Eurotherm Ltd – Notice of Improvements

This note refers to changes to Eurotherm instruments 2204e and 2208e - Communication module fastening clip.

New Expanding Clip Installation Instructions

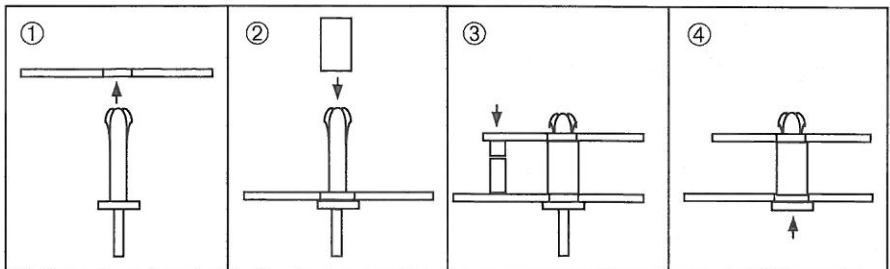
The support pillar that secures the communication module to the power supply board in the above instruments has been replaced in order to provide better support and reduce the possibility of connector damage.

The new pin fastener design requires a larger mounting hole and is not compatible with the old PCBs designed for the clip. Both fasteners are included in the pack to enable fitting to all instruments.

If this clip is being used as a service replacement, discard the old clip.

- ① Push the fastener through the hole in the Power Supply Board from the bottom side
- ② Slide the spacer over the end of the fastener
- ③ Connect the communication PCB onto the Power Supply board, making sure that the connector is correctly aligned
- ④ With the assembly on a flat surface, hold securely, and press the pin into position until the top of the pin is flush with the body
